TRANS/WP.29/GRSP/33
29 August 2003

Working Party on Passive Safety (GRSP)

REPORT OF THE WORKING PARTY ON PASSIVE SAFETY (GRSP)
ON ITS THIRTY-THIRD SESSION

Figure 1

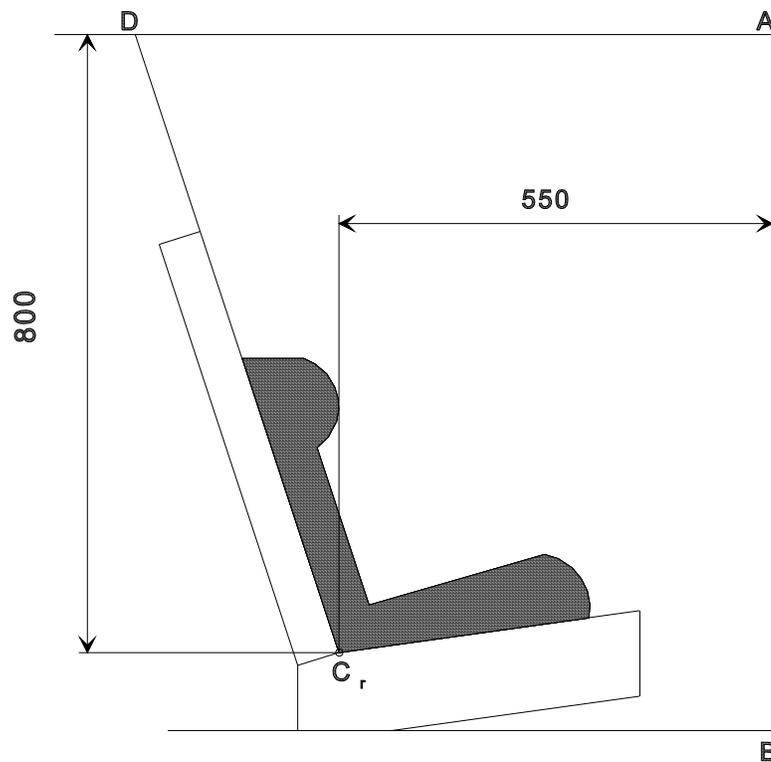
Paragraph 7.1.4.4.1.1., amend to read:

"7.1.4.4.1.1. Forward facing child restraints: the head of the manikin shall not pass beyond the planes BA and DA as defined in Figure 1 below. This shall be judged up to 300 ms or the moment that the manikin has come to a definitive standstill whatever occurs first.

Figure 2:
Arrangement for testing
a rearward-facing device

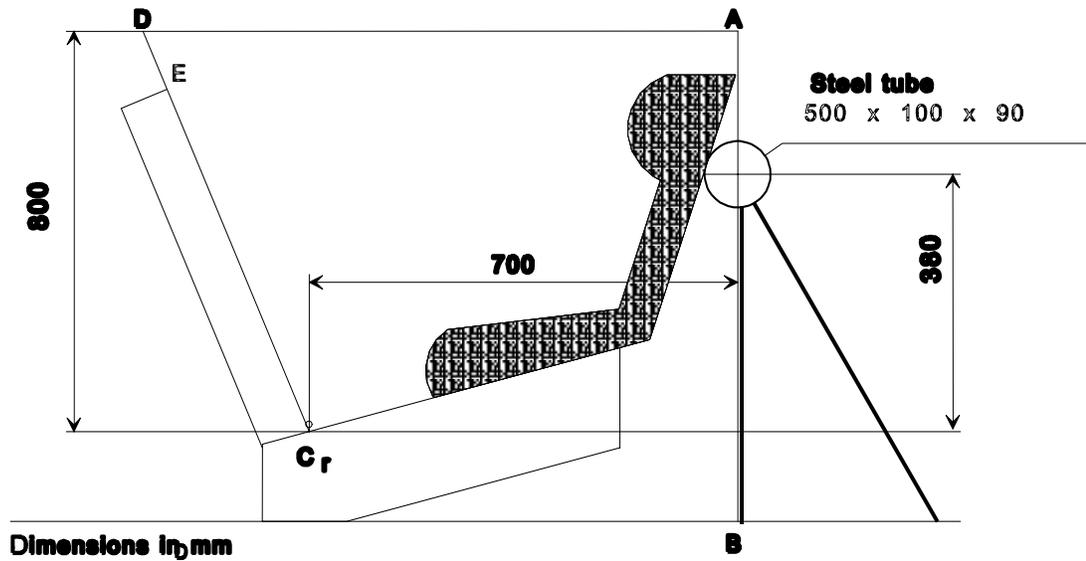
Paragraph 7.1.4.4.1.2.1., amend to read:

"7.1.4.4.1.2.1. Child restraints supported by dashboard: the head of the manikin shall not pass beyond the planes AB, AD and DC_r, as defined in Figure 2 below. This shall be judged up to 300 ms or the moment that the manikin has come to a definitive standstill whatever occurs first.

Figure 3

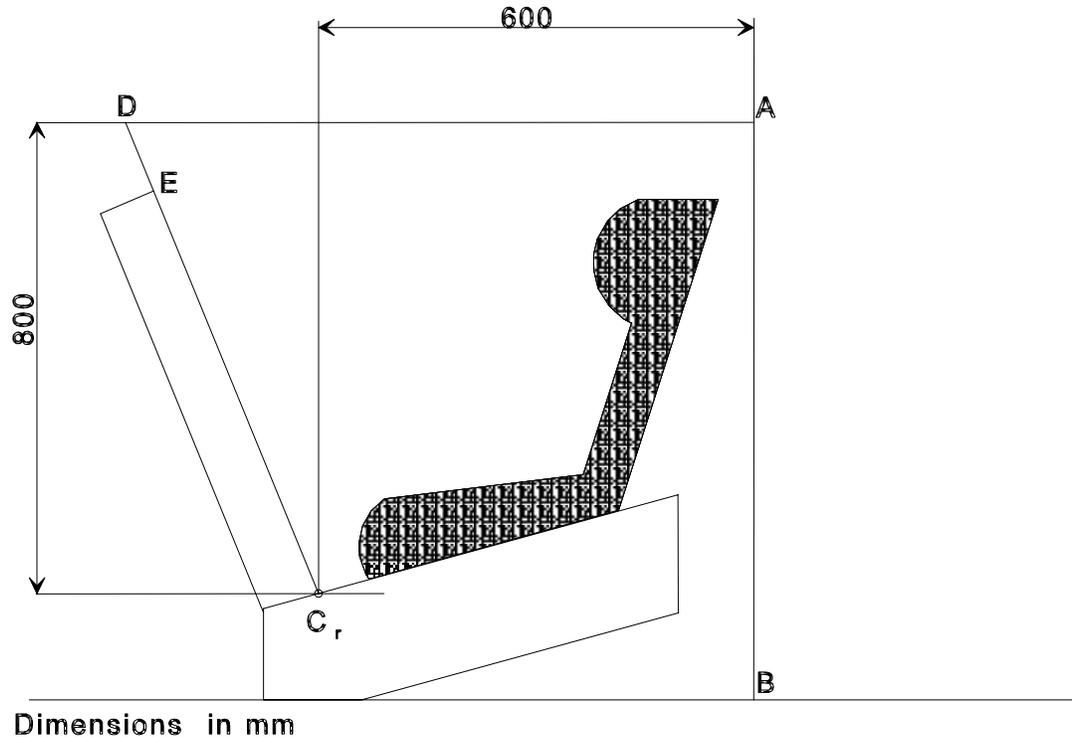
Paragraph 7.1.4.4.1.2.2., amend to read:

"7.1.4.4.1.2.2. Child restraints in group 0 not supported by the dashboard, and carrycots: the head of the manikin shall not pass the planes AB, AD and DE as shown in Figure 3 below. This shall be judged up to 300 ms or the moment that the manikin has come to a definitive standstill whatever occurs first.

Figure 1: Standard seat belt configurations"

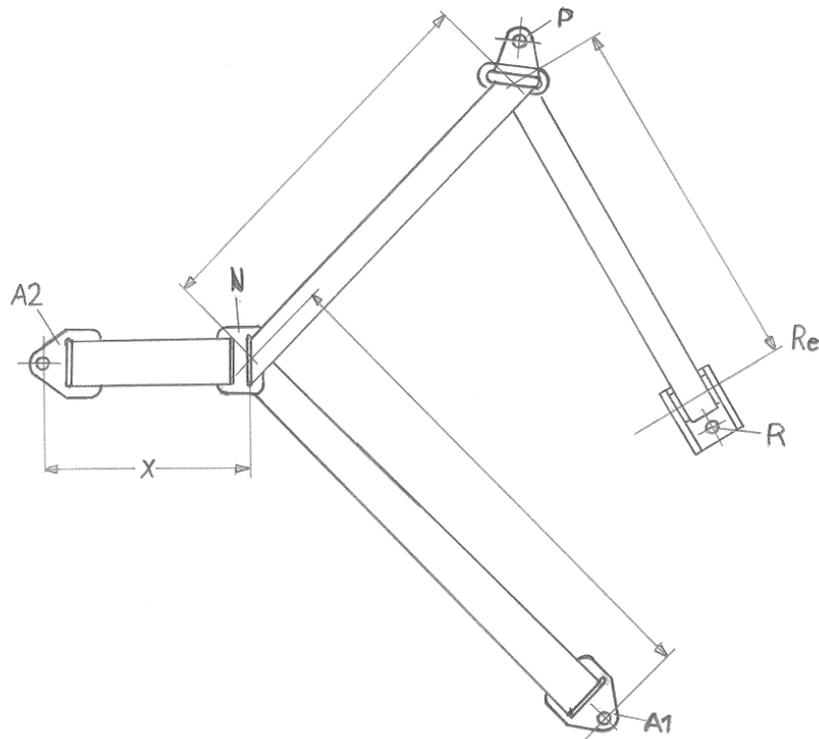
The value of X in Figure 1 below is 200 ± 5 mm. The effective strap length between A1 and the centre-line of the retractor spool Re (when the webbing is fully extracted including the minimum length of 150 mm */ for testing of universal and semi-universal categories) shall be 2820 ± 5 mm when measured in a straight line without load and on a horizontal surface; this length may be increased for testing of restricted category; for all categories with the child restraint installed there shall be a minimum of 150 mm */ of strap length on the retractor spool."

Figure 1., amend to read:
